MEMORANDUM

To: The Design Advisory Board
From: Mary O'Neil, AICP, Senior Planner
RE: ZP 13-0991 SP; 256-258 and 260-262 North Winooski Avenue
Date: May 28, 2013

File: ZP 13-0991 SP
Location: 256-258 North Winooski Avenue and 260-262 North Winooski Avenue
Zone: NMU **Ward:** 2
Date application accepted: April 30, 2013
Applicant/ Owner: Gates and A. Marsh Gooding
Request: Combine 256-258 and 260-262 North Winooski Avenue; demolish all buildings, construct 2 new three story buildings with a total of 23 residential units and 1 commercial unit. Parking for all 24 units will be provided on-site. A shared access drive with Legal Aid is proposed.

DRAWING:
SITE PLAN
 (SHARED DRIVE)

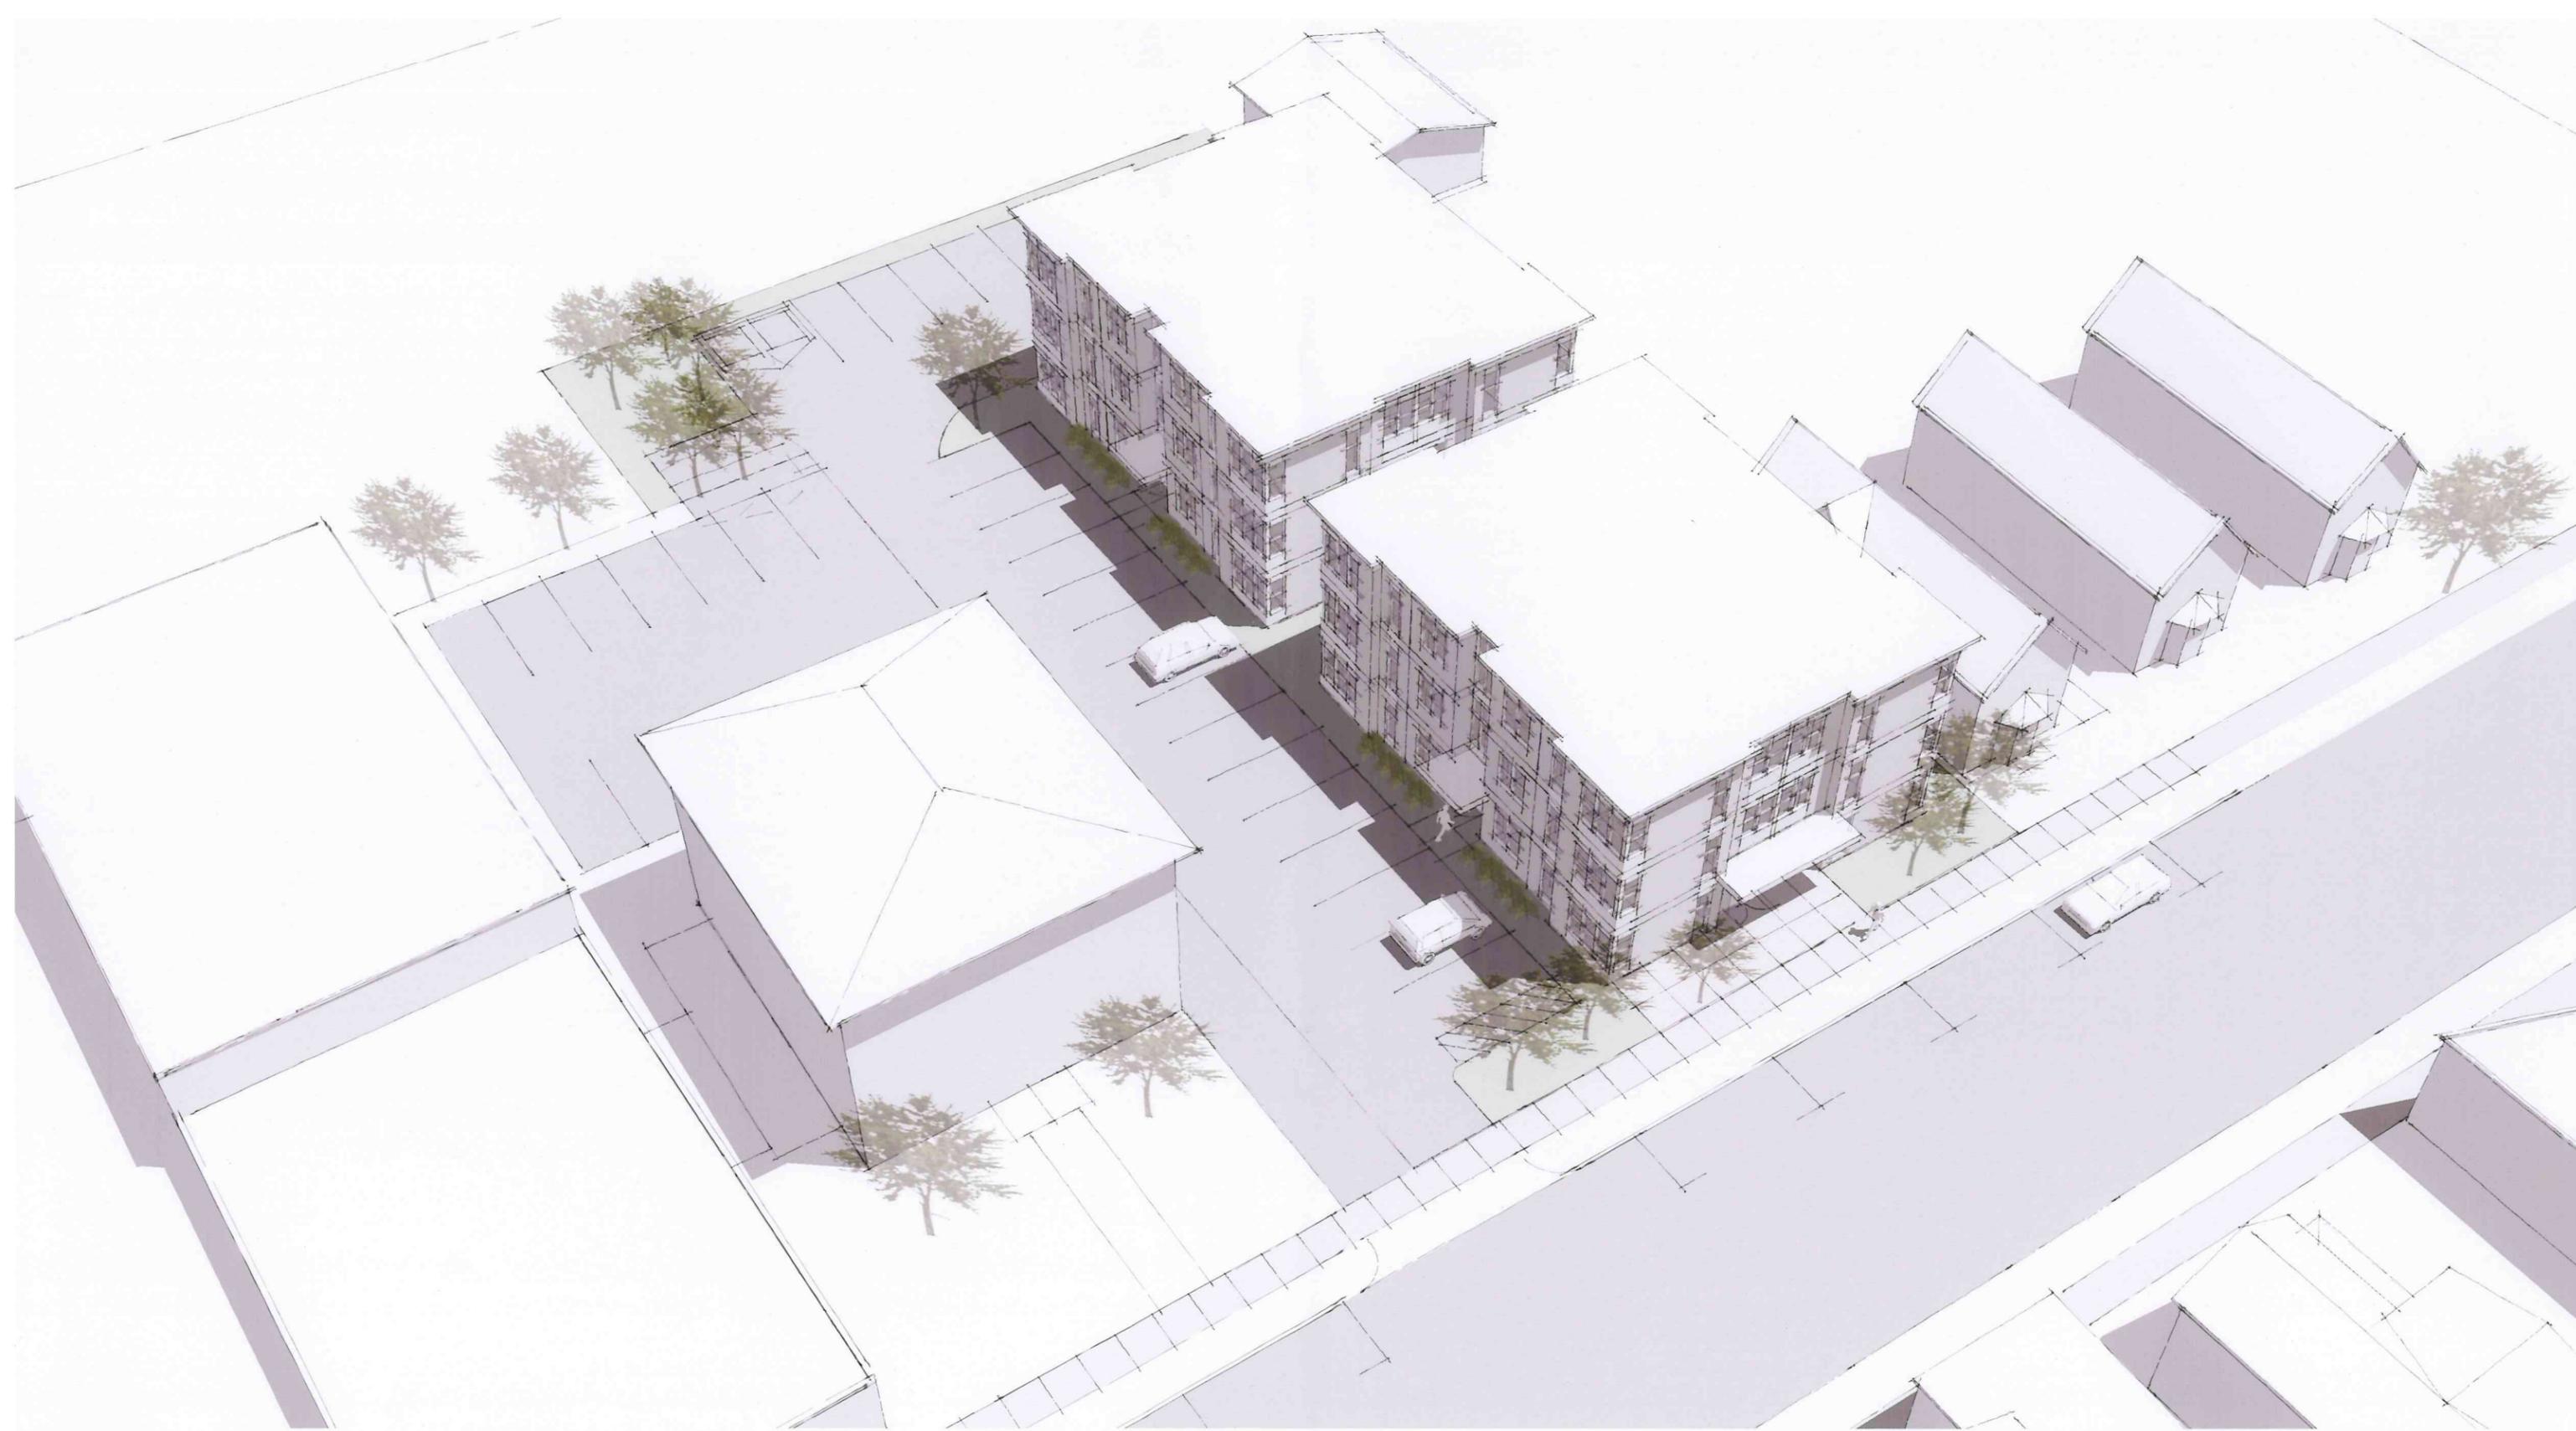
Entryways incorporate roof overhangs or covered shelter, as proposed. An area of snowstorage has not been identified, and needs to be.

The proposal includes a two lane shared drive with the adjoining Legal Aid property. This will reduce existing curb cuts from 3 to one.

The shared driveway is accompanied by a paved parking area. The parking setback (at the sides and rear, adjoining the residential district) is illustrated at 5’.

A trash enclosure is proposed for the north – east rear corner of the 260-262 North Winooski Avenue parcel. The applicants will need to define the specifics of the enclosure (fencing, etc.) to meet the design review guidelines of this section.

Direct pedestrian access is proposed from both the public sidewalk and the parking area on the east. There is no physical separation between pedestrian walk areas and the parking lot. A method of safe separation should be considered and developed. At Technical Review, a sidewalk access was recommended between the parking lot and the front entrance, to address the likely “desire path” that would occur over proposed green space at that location.

1 handicap parking space is illustrated on the site plan. An accessible entry is recommended; a fully accessible unit is encouraged.

The proposed parking is on the side and rear of the lot. 25 parking spaces are proposed; the parking area divided into two sections. The parking is setback from the edge of the front property line, and proposed to be screened with landscaping.

Adequate turn-around space appears to be provided; no vehicles will be required to back out onto the street. The perimeter of all parking areas will need to have barriers to prevent parking lot creep and destruction of green space.

For 25 parking spaces, 5 shade trees meeting the caliper size specified will need to be provided to meet this standard. 8 trees are illustrated in immediate proximity to the parking areas, meeting this provision. Additional landscaping (or fencing) is recommended along the rear (east?) property line to shield neighboring properties from headlight glare.

There is no identified walkway that separates vehicles and pedestrians within the circulation areas of the parking lot. The entrances, however, are visually clear and evident for building entrance. It may be prudent to articulate a small pathway for resident use on the east elevation along the front of the parking areas leading to entrances to minimize pedestrian/vehicular conflict. Additionally, DPW has recommended a paved path between the parking area and the front entrance, to anticipate the “desire line” of traffic from the parking lot to the main entrance.
